Product hierarchy no. *			Part no.	SBU	Type / Description	Customer part no.
SBU PG	PGU	Type				
02 006	016	0000001603	See list below	Power Entry Module with Filter	DF12

New internal wiring.

DF12					0118.2263	
creation date	created by	release date	released by	notification no.	revision	page
2015-01-19	huberth	2015-08-05	huberth			1 of 2

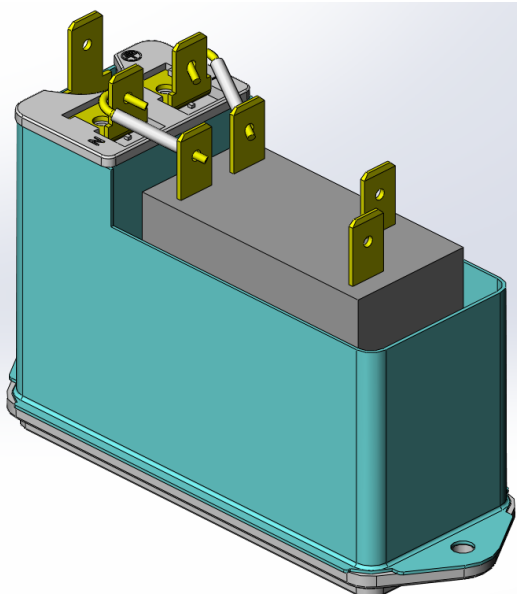
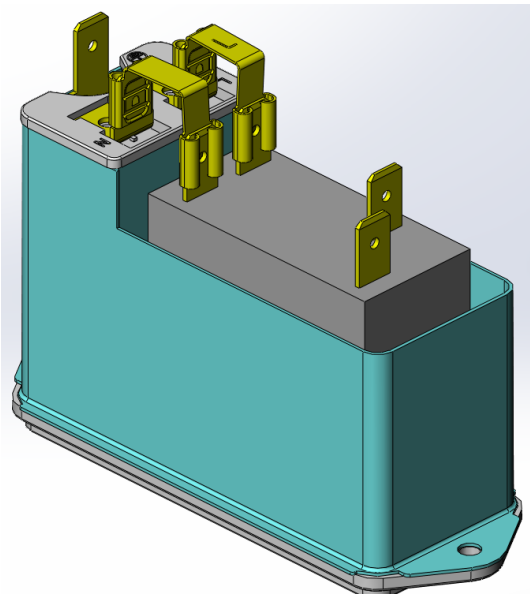
Soldered wire connection between filter and circuit breaker replaced by faston connection.

Elimination of the critical soldering process on the quick connect terminal.

Form: Yes New connection on back side, no change of outer dimensions.
Fit: No There are no dimensional changes.
Function: No This is a non-functional change.
Production Site: No There is no change of the production site.
Product Label: No There is no change on the label.
